**NOTICE OF
REGULAR MEETING OF THE PLANNING AND ZONING COMMISSION
HICKORY CREEK TOWN HALL
1075 RONALD REAGAN AVENUE, HICKORY CREEK, TEXAS 75065
TUESDAY, JANUARY 20, 2026, 6:00 PM**

2. Discuss, consider and act on a recommendation for a Preliminary Plat for the Chaffin Addition, Lot 1, Block A, being a 1.068-acre tract of land situated in the Lowry Cobb Survey, Abstract No. 284, Town of Hickory Creek, Denton County, Texas. The property is located at 204 Wild Oak Lane.

4. Discuss, consider and act on a recommendation for a Preliminary Plat for the 104 Carlisle - Hickory Creek Addition, being 3.164 acres of land situated in the Lowry Cobb Survey, Abstract No. 284, Town of Hickory Creek, Denton County, Texas. The property is located in the 700 block of S Lake Dallas Drive and is legally described as A0284A Cobb, Tracts 55, 58, 1.621 acres, A0284A Cobb, Tract 56, 1.2436 acres, and A0284A Cobb, Tract 57(PT), .4468 acres.

**Re: 104 Carlisle Drive (Lot 1, Block A – Hickory Creek Addition)
Preliminary Plat, Site Plan and Landscape Plan
1st Review**

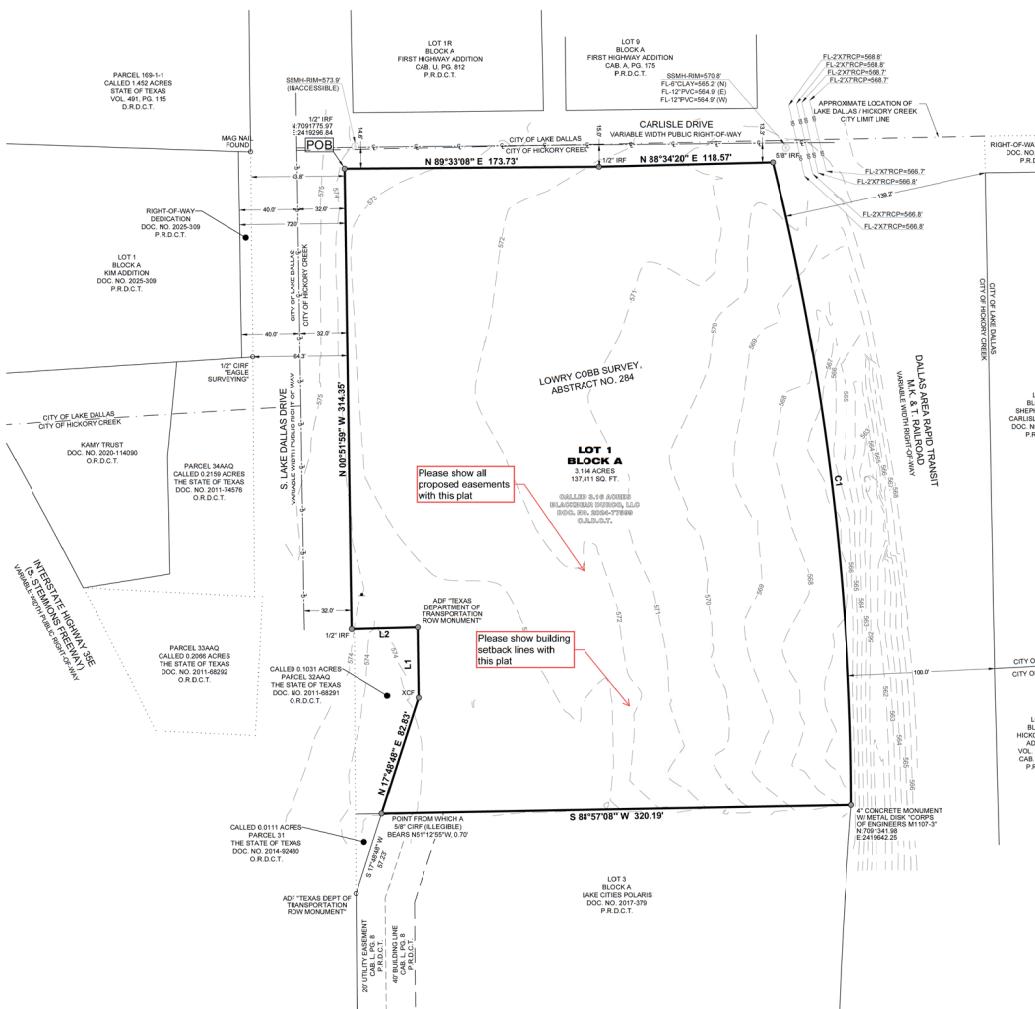
5. Please include/show all proposed easements with the plat.
6. Please include/show building setback lines with the plat.

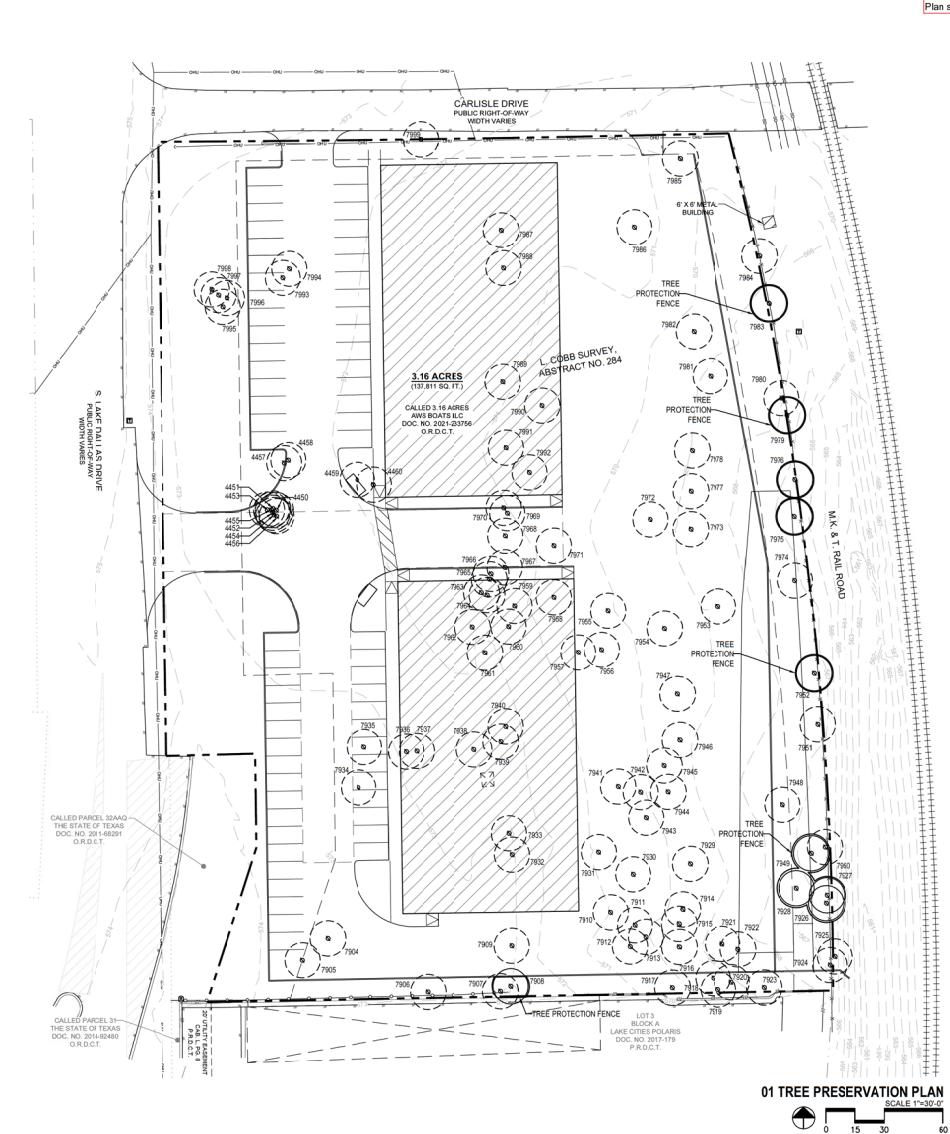
1. Please include the addition name, lot and block numbers, area in acreage, survey name and abstract number, and county in the title block.
2. Please label and dimension all barrier-free ramps on the site plan.
3. Please confirm intent/show any exterior lighting/pole locations that are proposed.

4. Please show and label existing and proposed water and sanitary sewer on-site and abutting the property.
5. Please show and label existing and proposed storm drain and inlets on the Site Plan.

6. Per Note 1 on the Site Plan, please call out the building heights within this note or on site plan.
7. Per Note 2 on the Site Plan, the assumption made in the note is unlikely to be the case due to ongoing RR coordination and LCMUA improvements proposed to occur within Carlisle Drive that have not yet been finalized for construction. Please consider this and adjust plans accordingly.

8. Add FEMA floodplain note from the plat.
9. Per Chapter 14, Article XXIV, Section 4, for Office square footage, 1 space per 200 SF must be provided. This will amend total required parking to 81 spaces. Currently providing 60.

11. Please add a Vicinity Map to the Site Plan.
12. Please callout the dumpster screening wall height and material on the Site Plan.
13. Please add county recording information for the subject property and for all adjacent properties.

14. Please include driveway approach radii on all driveways.
15. Please dimension the distance between the buildings on the site plan.
16. Please revise the railroad callout to be DCTA Railway.

01 TREE PRESERVATION PLAN

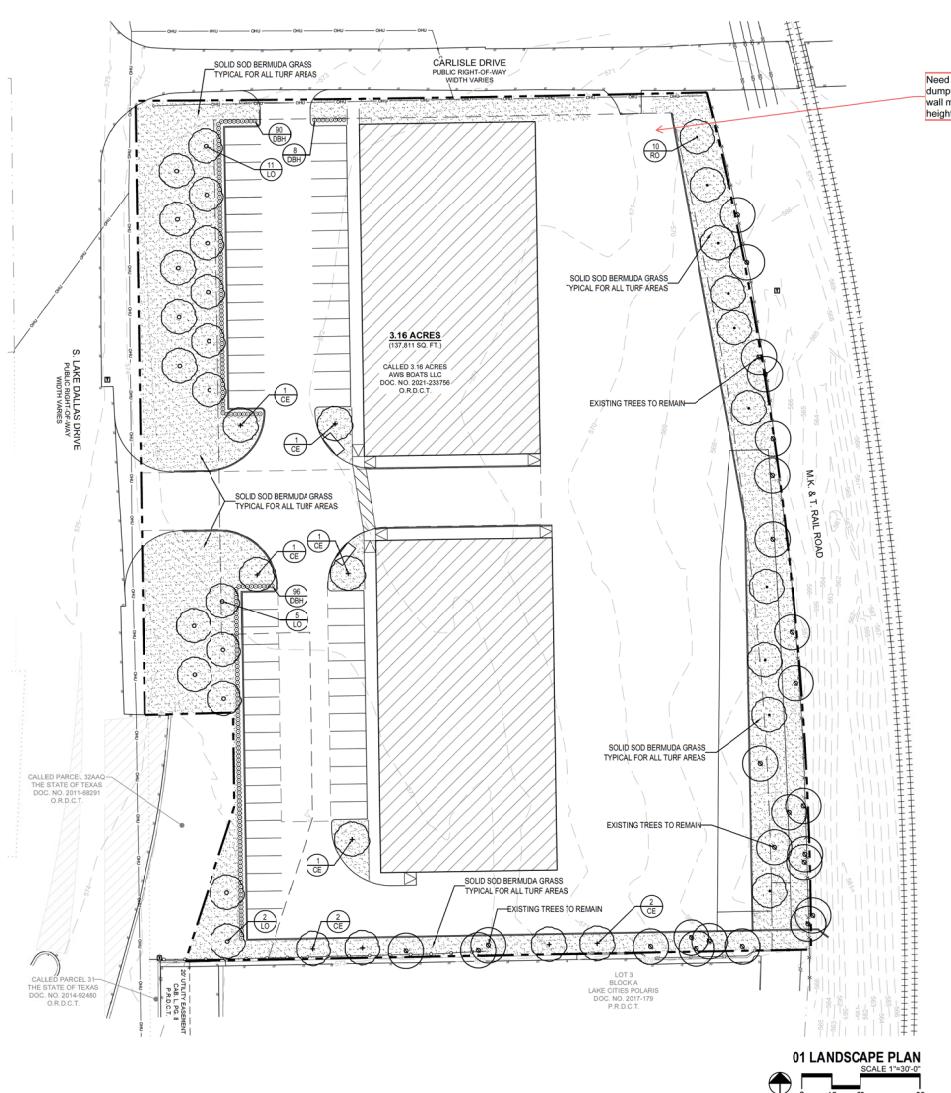
18. The evaluation on "Health" of the trees will need to be confirmed, signed or declared by an ISA Certified Arborist in order to qualify for exemption on mitigation inches for these trees deemed unhealthy, per Zoning Ordinance Section 10.02.004 Item h.4.A. This tree preservation plan sheet must bear the certified Arborist name and their ISA Certification number for confirmation

19. Please verify the calculated tree mitigation inches required per the markups.
20. Please show the dumpster screening wall materials and height on the landscape plan.

21. Verify landscape tabulations shown for tree credits, provided inches, parking spaces, and total trees provided. (See Markups)
22. Plans show planting of 37 trees at 3-inch caliper equaling 111 mitigation inches provided. Total mitigation inches required is 530 inches. Please confirm intent on the remaining 419 mitigation inches and if meant to be covered/paid in fee.

This evaluation will need to be confirmed/declared by an ISA Certified Arborist in order to qualify for exemption on tree mitigation inches per Section 10.02.004 Item h.4.A
Plan sheet must bear ISA Cert number and Arborist Name
